**YS-014-10**

**SUBJECT:** Defrost Issues and Coil Matchups

**UNITS:** YZE, YZH

094

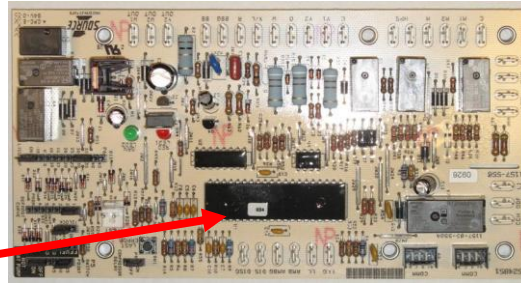
For field installed systems with poor reversing valve shift or noisy compressor during defrost cycle, the system control board should be replaced with one that contains modified software to introduce a shutdown sequence of the compressor during defrost transitions. The new York Guard VI control has a selectable 30 second compressor delay on the initiation and termination of the defrost cycle. This delay option is set in the off position on factory installed and Source One replacement boards, place this jumper in the “ON” position. A labor allowance of 90 minutes will be provided for replacement of the defrost board. **In most instances this change alone will resolve these field issues**, as it will create startup conditions for the compressor which avoids the noisy chatter, improves the pumping rate of the compressor which increases the speed of reversing valve shift, and decreases the shifting losses and accelerates and improves the defrost due to the better pumping rate of the compressor.

A non-communicating version of this new York Guard VI control (part # 524851) was installed in YZE and YZH units beginning in September 2009. The number 094 is located on the processor in the middle of this board. Fully communicating YZE and YZH units were released in November 2009 (the letters “CA” at the end of the model number designate Communication and 1st Generation). The York Guard VI board in these units (part # 500644) has the number 104 or 109 on the processor.

For units manufactured before September 2009, a labor allowance of 90 minutes will be provided for replacement of the previous version of York Guard VI control (080) to remedy incomplete defrost issues. The Source One part number for the new board is S1-33102957000.
